To: All Recipients of the Prospectus, CC-BLRI009-26, to Provide Food & Beverage and Retail Services at Mabry Mill within Blue Ridge Parkway

Service Responses to Offeror's Questions on Solicitation No. CC-BLRI009-26

AMENDMENT NO. 1
SOLICITATION No. CC-BLRI009-26

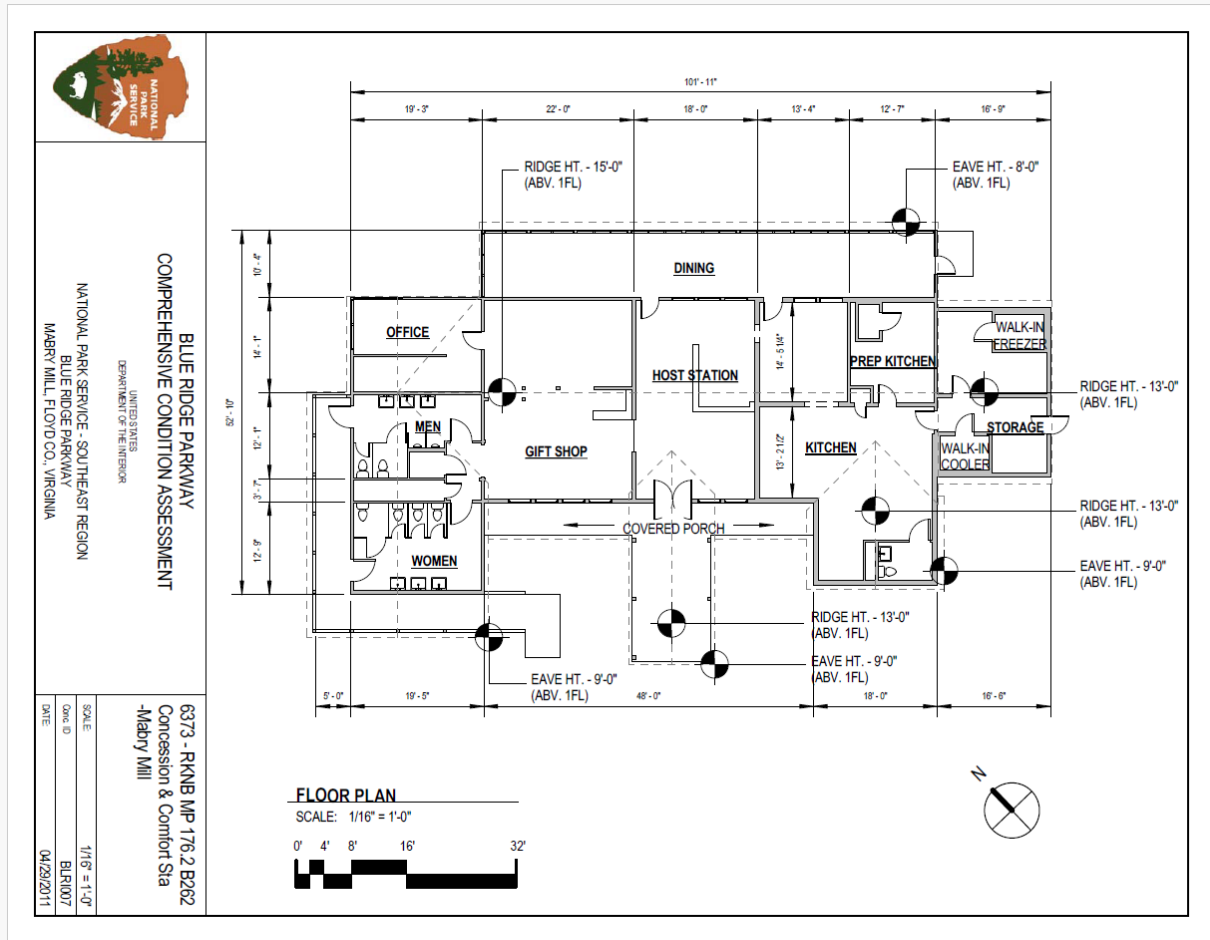
Question 22: Can we obtain a copy of the as-built plans for the building?

Answer: As-built plans can be provided to the winning offeror. At this time, the following drawing is available:
